BEFORE THE ENVIRONMENTAL QUALITY COUNCIL  
STATE OF WYOMING

In the Matter of the Appeal )  
And Petition for Review of: )  
BART Permit No. MD-6040 )  
(Jim Bridger Power Plant); and ) Docket No. 10-2801  
BART Permit No. MD-6042 )  
(Naughton Power Plant). )

**Decision and Response to Comments, dated 12/31/09**

IN THE MATTER OF A PERMIT APPLICATION (AP-6040) FROM PACIFICORP FOR A  
BEST AVAILABLE RETROFIT TECHNOLOGY (BART) PERMIT FOR THE JIM BRIDGER  
POWER PLANT

VISIBILITY MODELING RESULTS (Baseline vs. LNB and SCR)

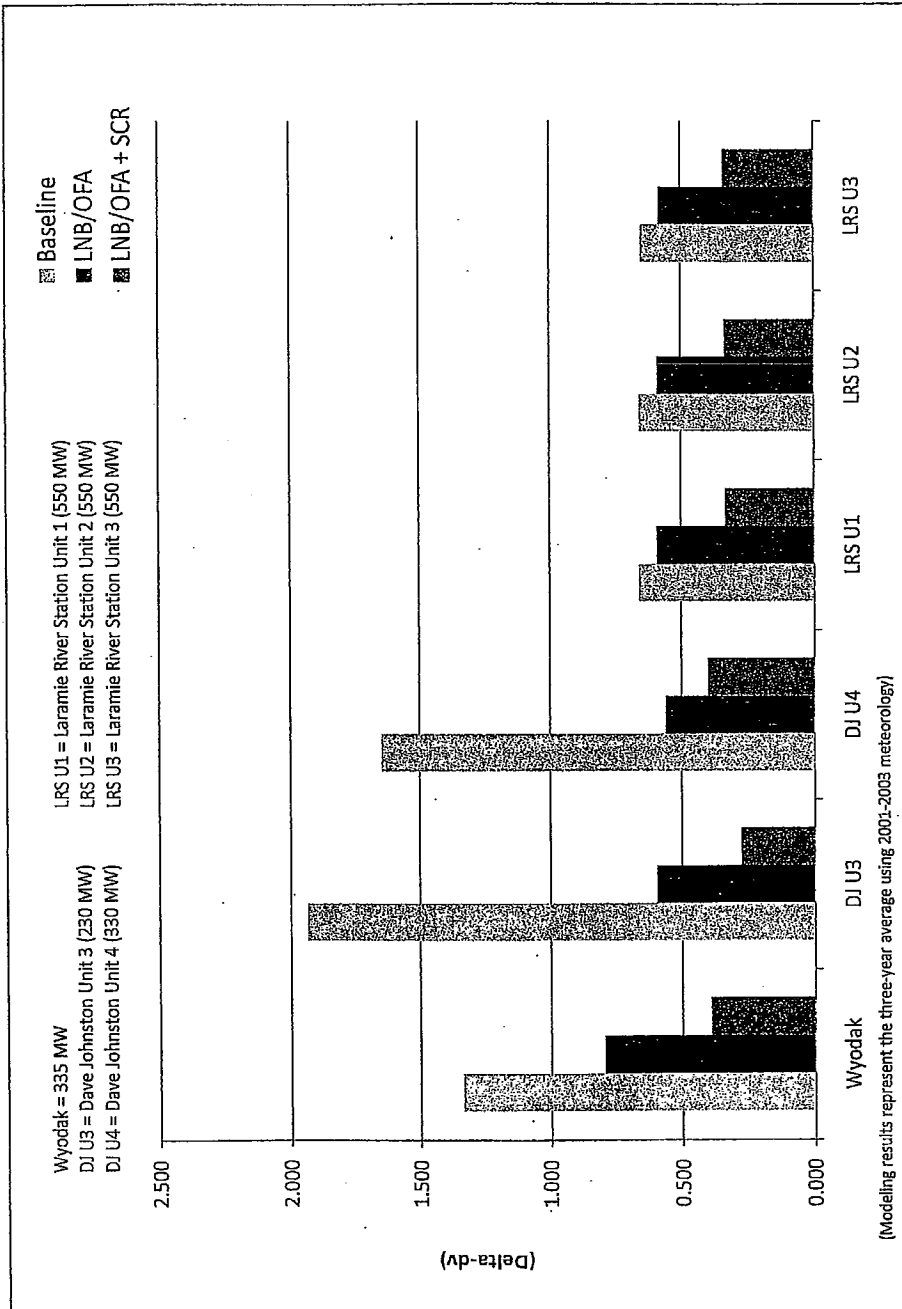
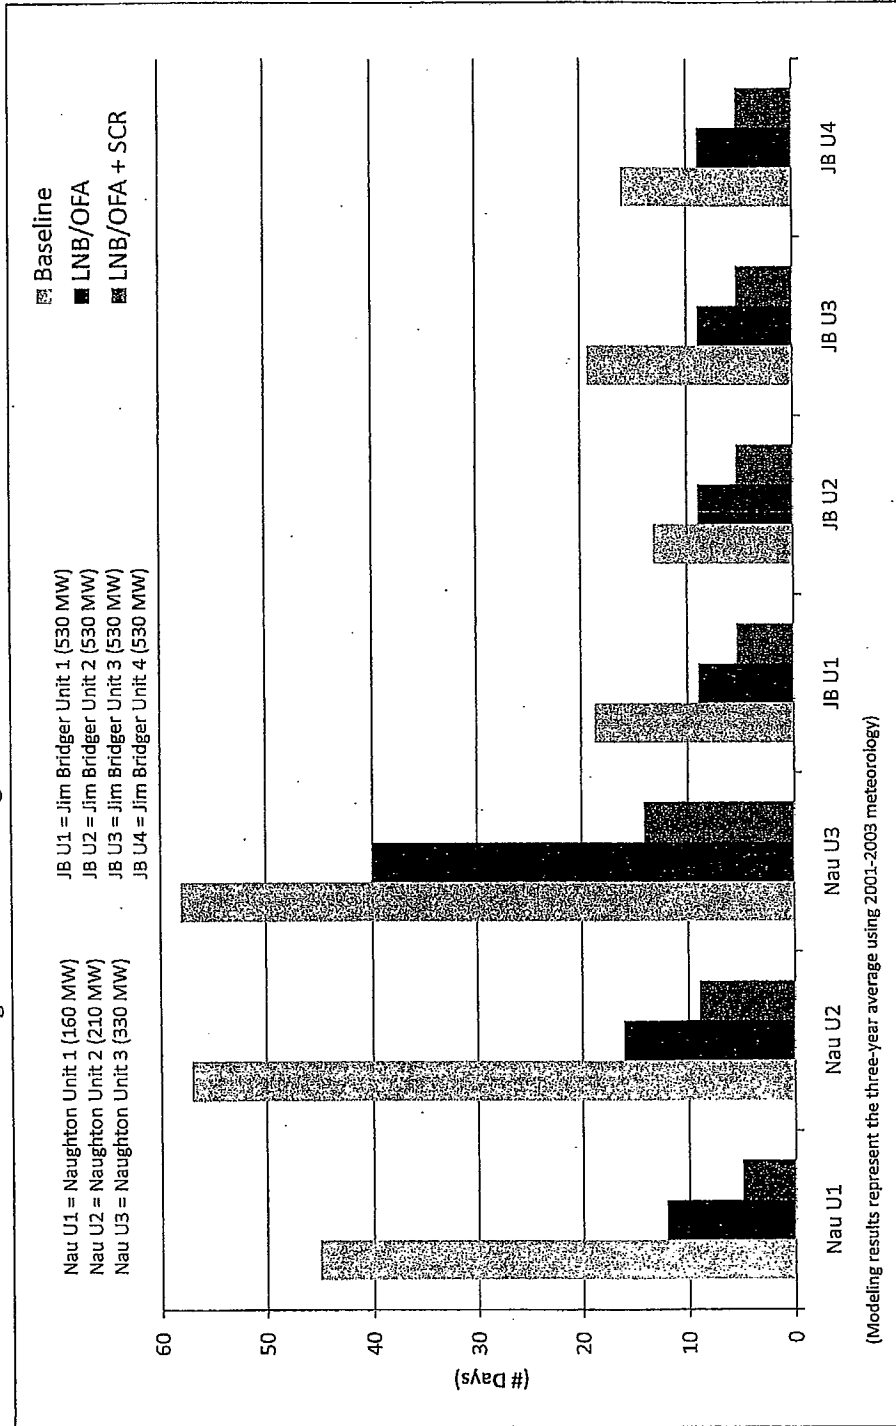
**Response** – The Division did not rely solely on the three-year average of the 98<sup>th</sup> percentile CALPUFF results to evaluate the expected visibility changes for the BART control options. The 98<sup>th</sup> percentile values and the number of days with predicted results above 0.5 dv were presented in the Division's BART analyses for each of three modeled years, for each Class I area, and for each control option. The three-year average of the 98<sup>th</sup> percentile results and the number of days above 0.5 dv were chosen for graphical representation and were mentioned prominently in the Division's conclusions because they offered the clearest comparison of one control option to another (see graphs in Appendix A).
